FAQ Number 13-0002 FAQ Revision 0n1

FAQ Title Modeling of Main Control Room Abandonment on Loss of Habitability

Plant: Various Date: 16~~3~~ AugustJuly 2013

To clarify the expectation for modeling of control room abandonment for fire scenarios in the main control room (MCR) that lead to a loss of habitability.

Figure 1 - Flow Chart for Abandonment Due to Loss of Habitability (LOH)

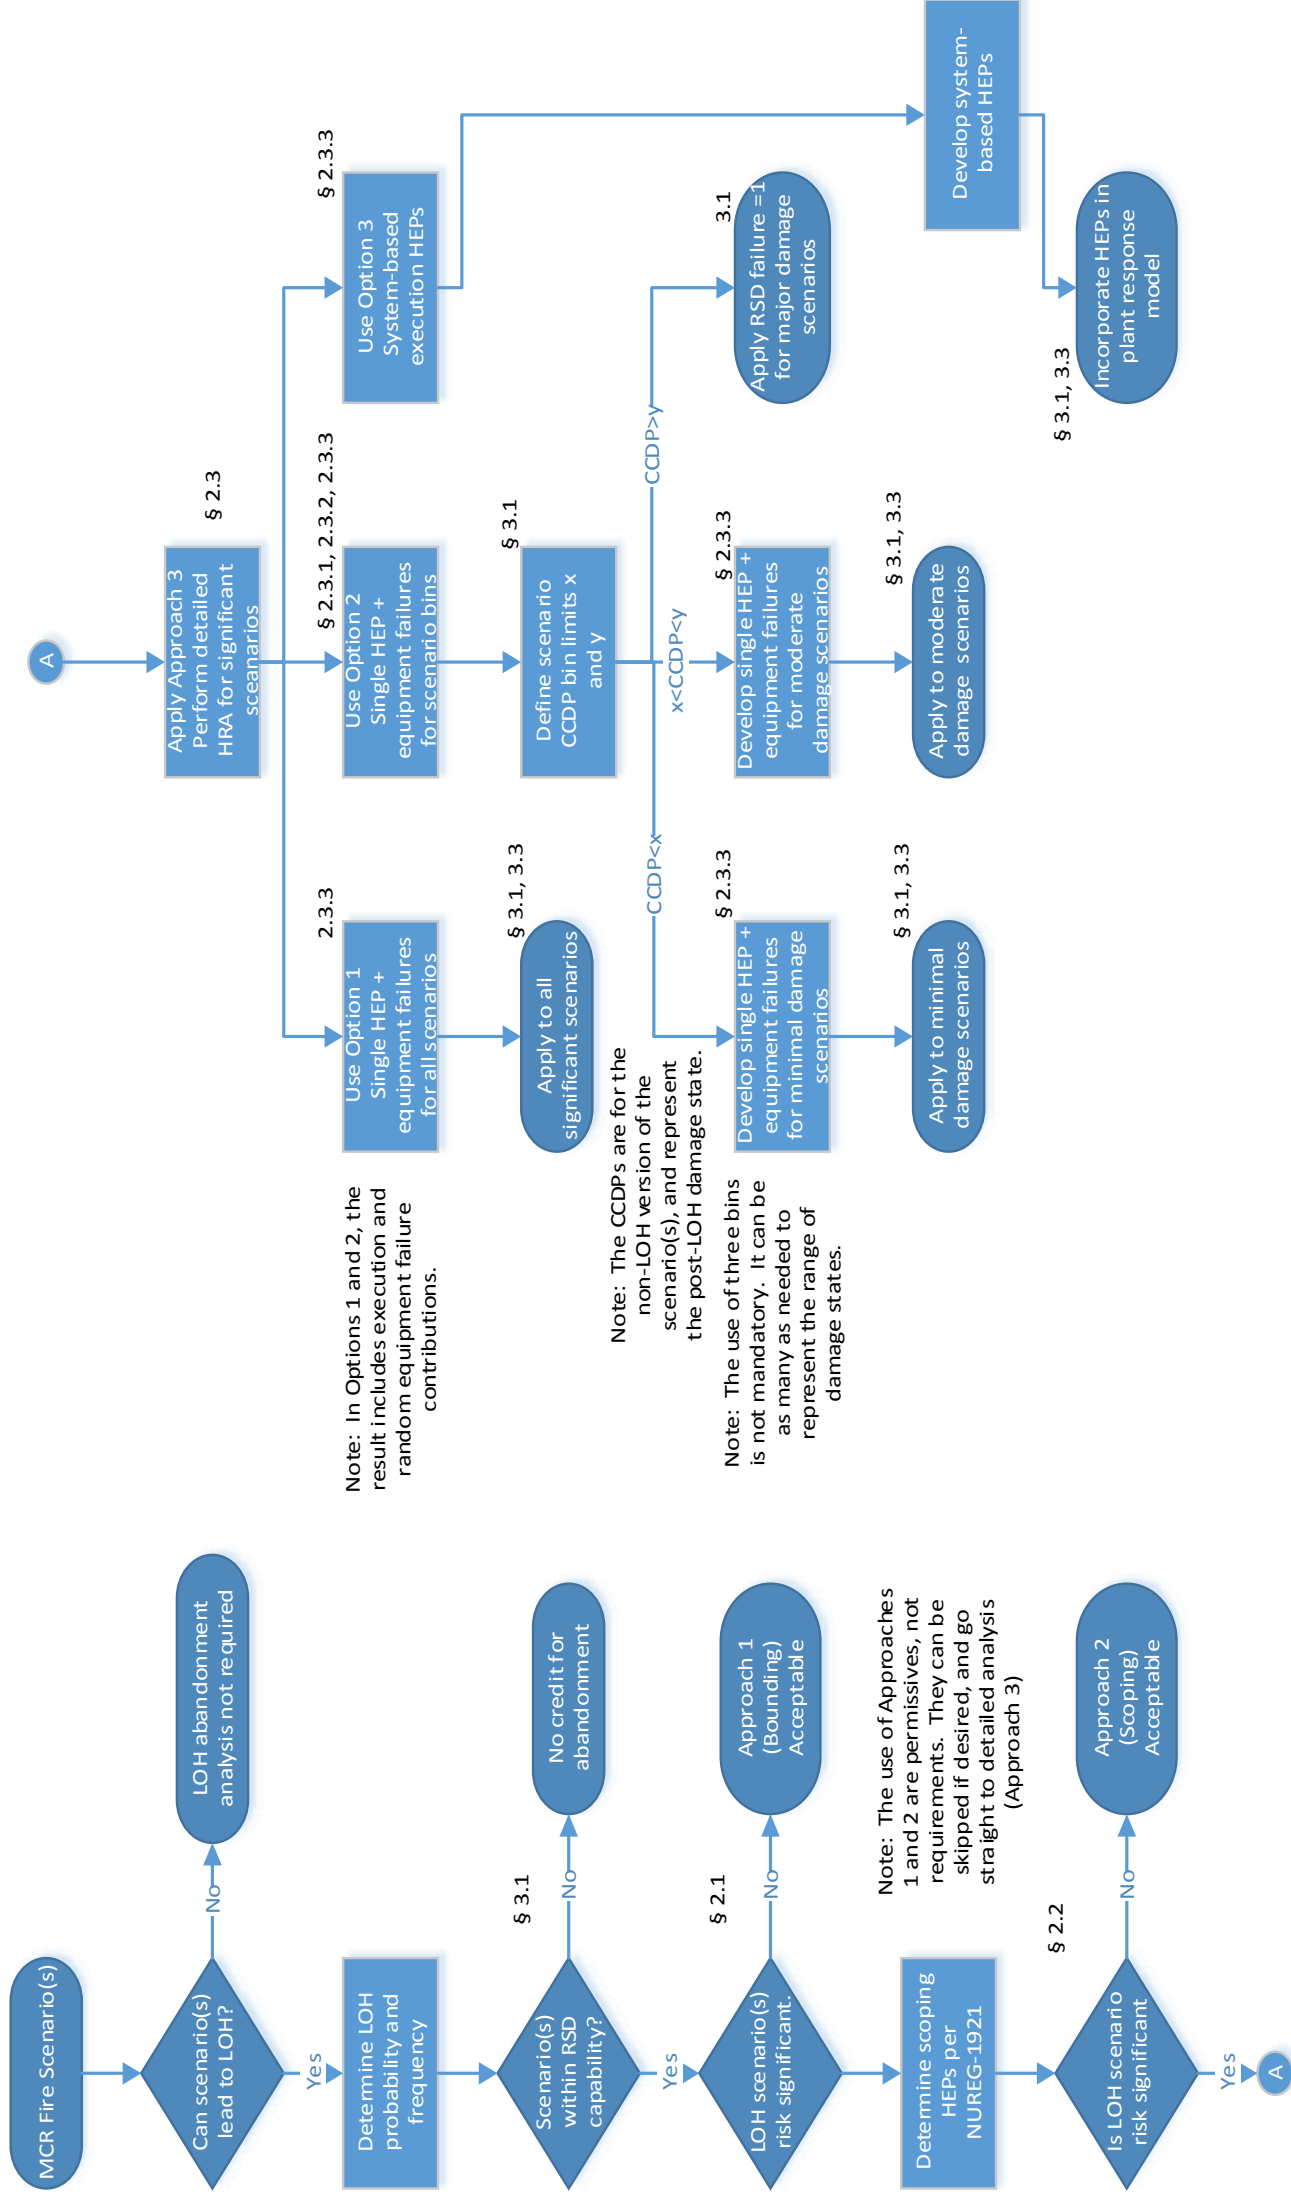
**Comment [O9]:** We need to have discussion regarding the figure. It's not clear first of all, why a single HEP constitutes a detailed HRA analysis. We need to understand the rationale here. Secondly, the discussion under Option 2 of Approach 3 seems to be overblown. We do not understand the need for such a complex addition to the table.

**Comment [J52]:** The table seems like overkill. Isn't the point to map sequences on MCR abandonment, and to use the most restrictive scenario from the bin for quantification? What else is the table conveying.

**Comment [O56]:** I'm afraid that this part of the approach is confusing to me, especially without explicitly defining  $z_1$  &  $z_2$ .

**Comment [p10]:** Further clarification is added later in the text. Summary of rationale is in the comments added below.

**Comment [p11]:** Rationale for option 1. If we accept the concept that scenarios can be binned and an HEP based on the worst case in a bin, then this simply address the case where there is only one bin (all LOH scenarios) and the worst case is used for the HEP. It is detailed because it is based on a plant-specific modeling of the procedures and actions required for that scenario.

**Comment [p12]:** Rationale for option 2. This addresses the option for binning scenarios based on CCDP bins. This was an approach that was used for some plants and that NRC said was acceptable. Including it in the FAQ establishes it as acceptable and provides guidance for applying it acceptably.

**Comment [p53]:** Again, this approach was used by some plants and was found agreeable by NRC. We would like to document that.

**Comment [p57]:** It is not possible to establish specific values for  $z_1$  and  $z_2$ . They would be plant specific, based on the worst case scenario in the bin.
